SUBJECT: Refers to questions re cracking Susquehanna SES CRD bolts disposition during last refueling and inspection.

SUSQUEHANNA STEAM ELECTRIC STATION
QUESTIONS REGARDING CRD BOLT DISPOSITION
PLA-3083 FILES R41-2, A22-7F

This letter is to document PP&L's responses to questions from your staff regarding the cracking in Susquehanna SES CRD bolts which were removed from the Unit 2 during the last refueling and inspection outage. The questions and our responses follow:

FIGURE 1. Cross section of two CRD bolts from Unit 2 of Susquehanna showing the depth of the cracks and pitting. Note also the MnS stringers oriented in parallel with the fillet under the head from the forming operation. (38.5X after reproduction)

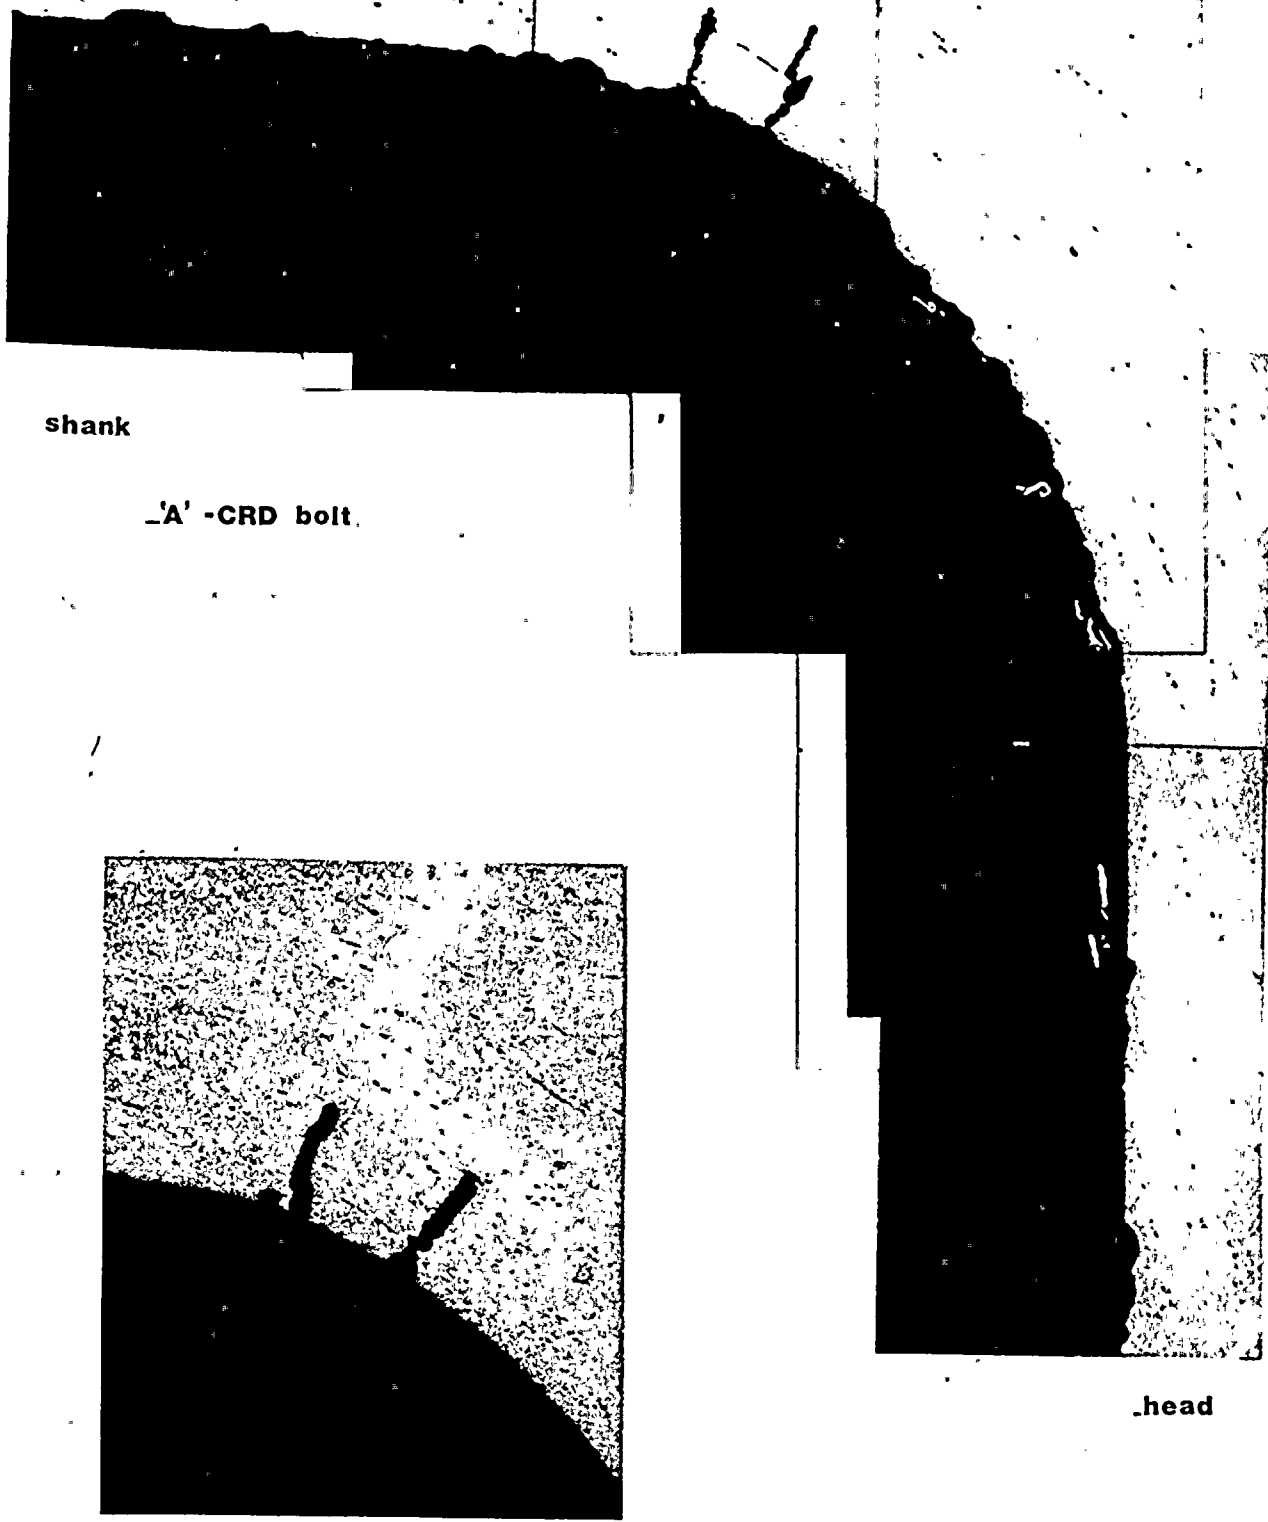
- 2) What was the manufacturing process for the bolts?

From the cross-section we took of the bolt head area, we were able to determine that it must have been some hot or cold forging of bar stock. The evidence for this is shown in the attached photograph of the fillet area where elongated MnS stringers are shown parallel to the fillet surface. We have to conclude that the bolts were not machined from a larger bar stock since that would have given us a cross-section with stringers all parallel to the bar shank.
